Zoning Staff Report

Case Number: ZC-21-147

Zoning Map Amendment

PERCH CHISHOLM TRAIL PH 1
 Fort Worth, TX
 Zoning Case Number: Case ZC-21-147

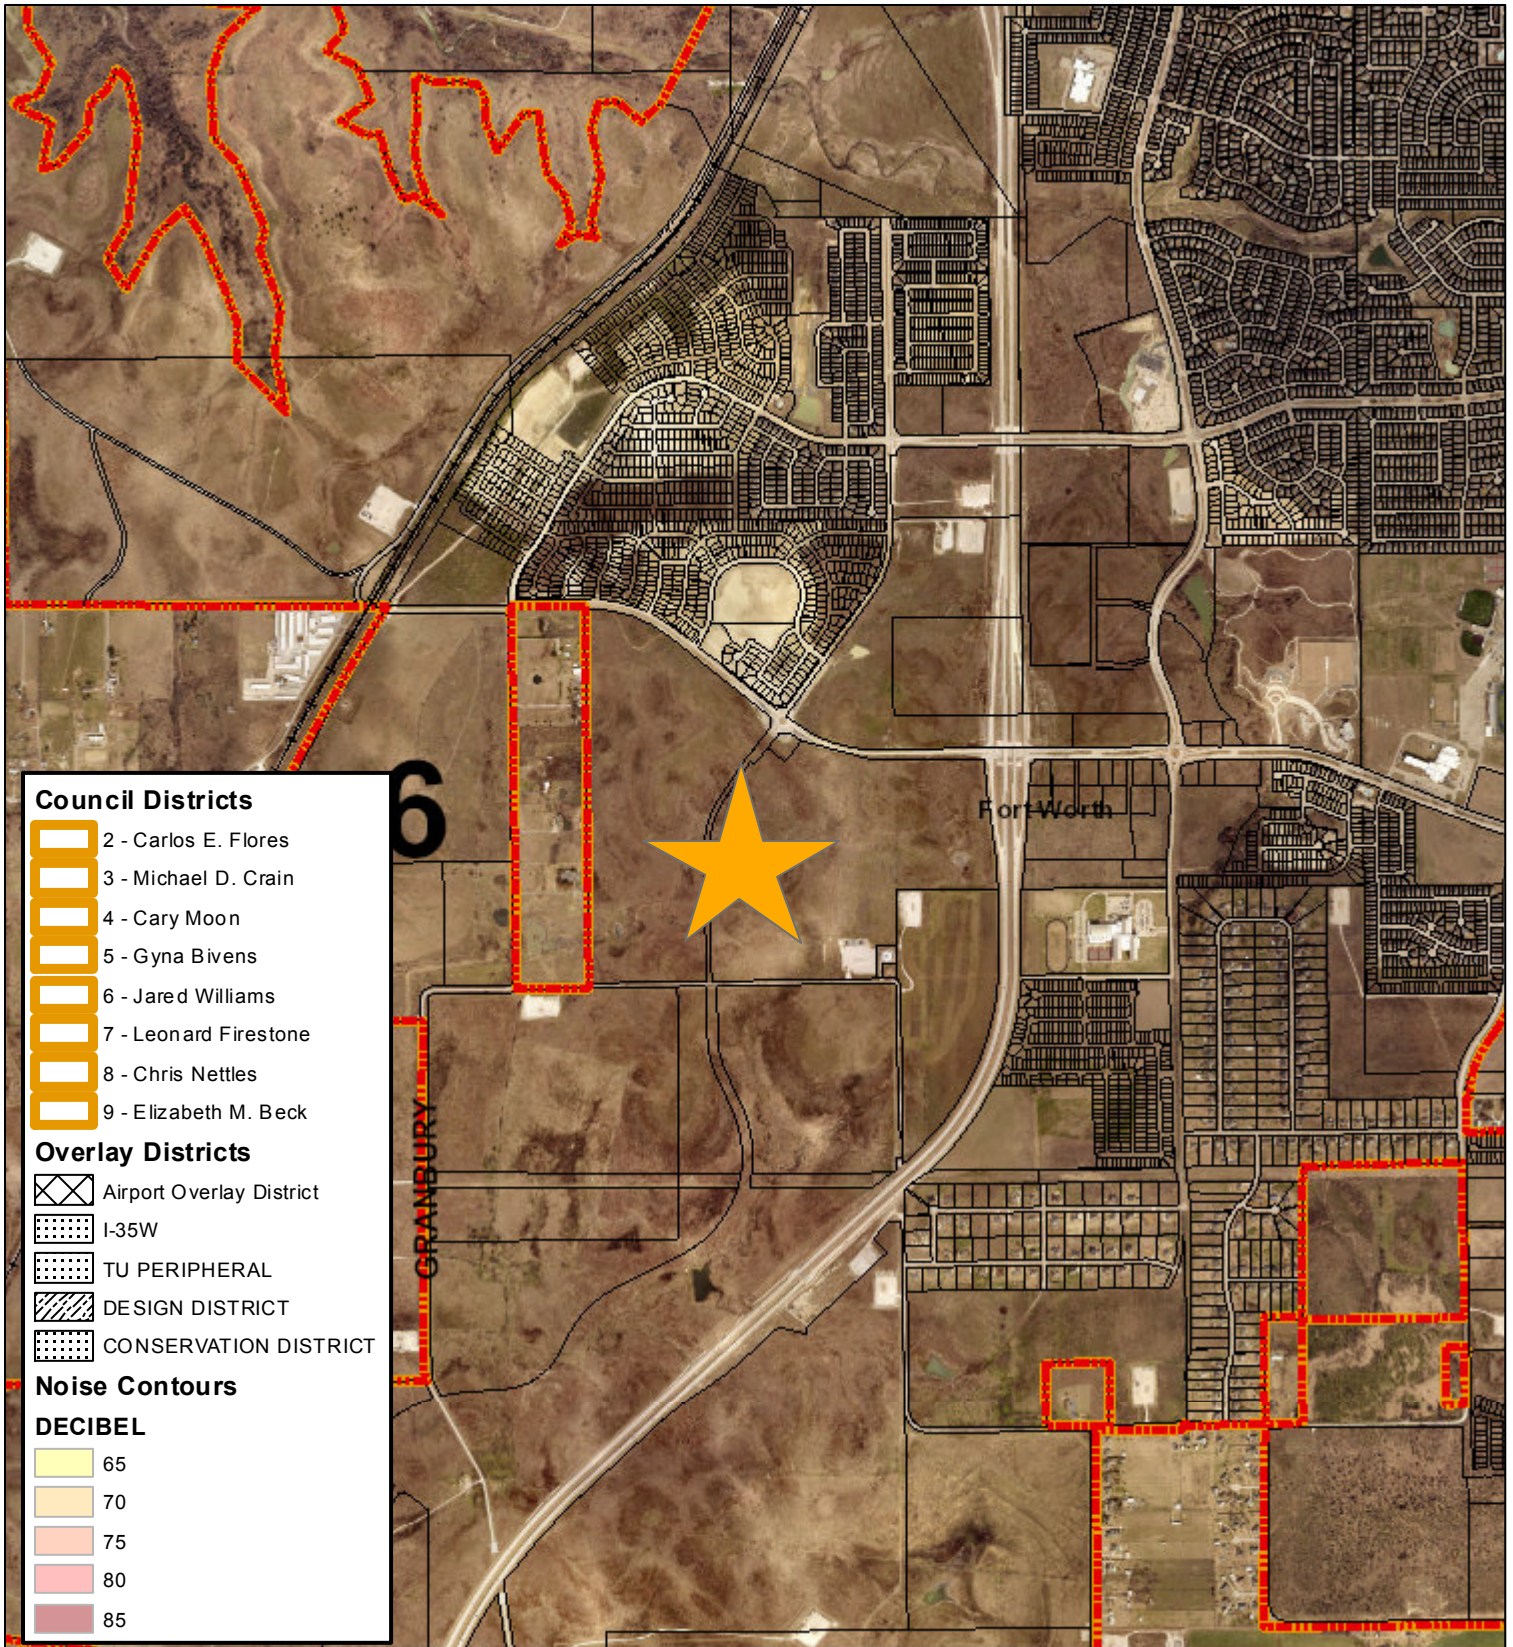
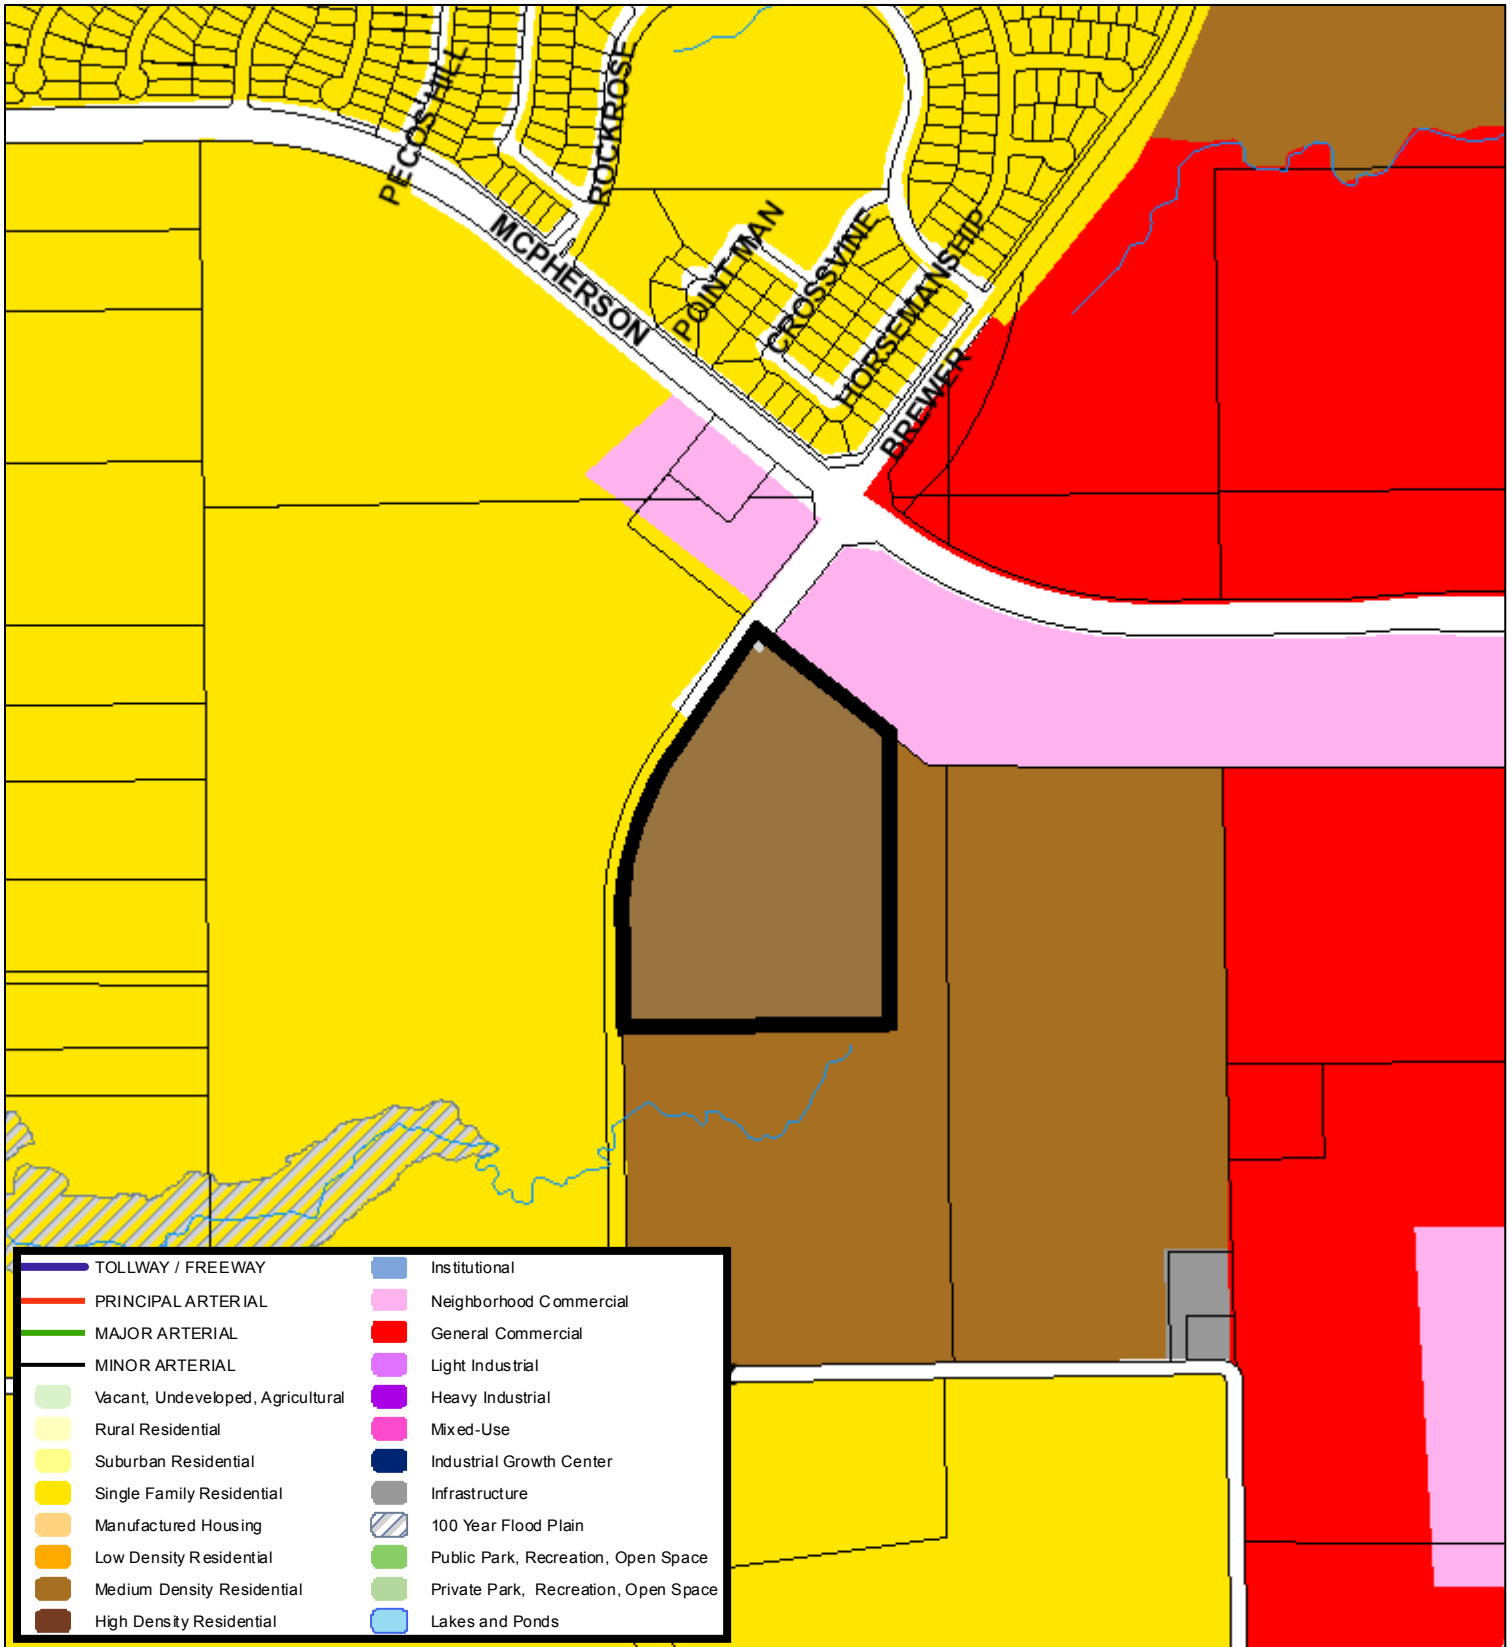
- Please clarify how the 25% open space percentage is being calculated. The minimum requirement for “D” zoning is 35%, so a development standard will be required. Per Ordinance Section 4.712(7)(g), no space less than 25 feet in either direction can be counted as open space.

- FYI – areas used towards credit for minimum open space requirements cannot also be credited towards enhanced landscaping requirements for the “D” High Density Multifamily District.

- (Zoning has agreed to let the zoning case move forward with the preliminary plat review, should the plat be denied the applicant would have to continue or withdraw the application). A preliminary plat has been submitted that includes the lot for ZC-21-147 and PD1305. A waiver is required from the City Plan Commission for the block length exceeding 1,000 feet per [SO. Section 31-106(20)(d)(3)]. The plat is expected to go before City Plan Commission on September 8, 2021. **(This waiver request was approved)**

- Multi-family developments of 100 dwelling units or more shall have a platted and constructed secondary ingress and egress to a public street.
- Gated entrances into secured areas must be designed in accordance with TPW’s “Traffic Engineering Design Standards and Policy Guidelines”. Provisions for an acceptable turnaround must be made. Gates must be located 3 vehicle lengths from the ROW.

Analysis: The applicant is requesting that the fenced rear yard areas adjacent to each unit be credited towards the proposed 25% open space requirement. Detached multifamily operates differently than traditional “D” High Density Multifamily developments. Due to the separation of individual, detached units, the public open space is often smaller than the 25’x25’ minimum dimension. For the purpose of this site plan, the enclosed yards for each dwelling unit will be acceptable as open space. The yards, while private, are open spaces that each resident can use, as a yard is provided for each unit.
